SDP-0318-H3

The Preserve at Piscataway, Lot 81B (Mitchell Deck)

SUBJECT: Homeowner's Minor Amendment to Specific Design Plan SDP-0318-H3
The Preserve at Piscataway, Edelen Village, Lot 81B (Mitchell Deck)

SITE PLAN

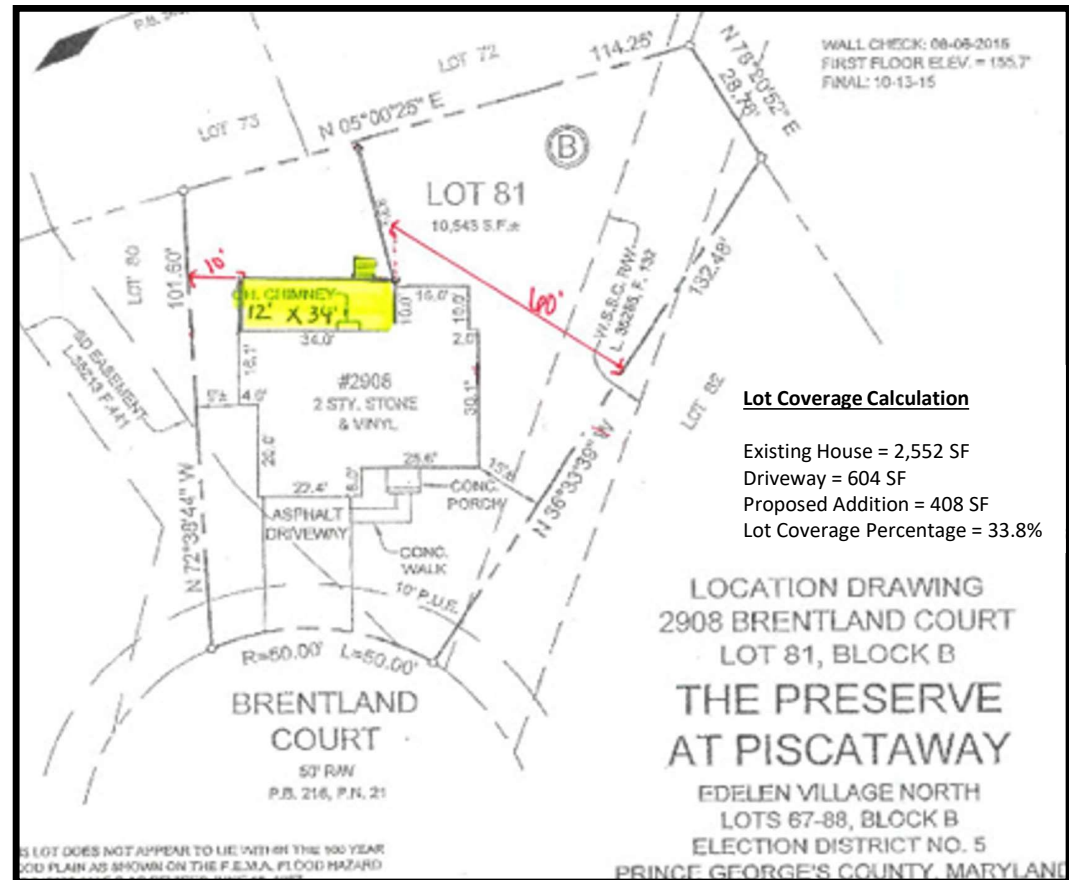
9. **Comprehensive Design Plan CDP-9306:** The project complies with the requirements of CDP-9306, except regarding the required rear yard setback. The CDP stipulates that the minimum rear yard setback for single-family detached houses, with a lot size below 20,000 square feet, is 25 feet. The proposed deck and steps would sit approximately 21 feet from the rear property line, encroaching into the rear setback by 4 feet.

11. **Specific Design Plan SDP-0318:** SDP-0318, for Edelen Village North and South, was approved by the Planning Board on June 10, 2004 (PGCPB Resolution No. 04-135), with 25 conditions, for 108 single-family attached lots, recreational facilities, and an associated parking facility. The subject application is in compliance with the requirements of SDP-0318, except for the rear yard setback, for lots with a lot size below 20,000 square feet. The proposed deck would extend into the designated 25-foot setback by 4 feet.

setback of approximately 21 feet from the rear property line. The subject application does not meet Criterion (A) and, therefore, the subject homeowner's minor amendment to SDP-0318-H3 is to be heard by the Planning Board, as stated in Section 27-530(d)(3)(A).

1. Provide a revised and legible engineer's site survey that:
 - a. Properly demonstrates and dimensions the right-side setback.
 - b. Includes the lot coverage calculation.
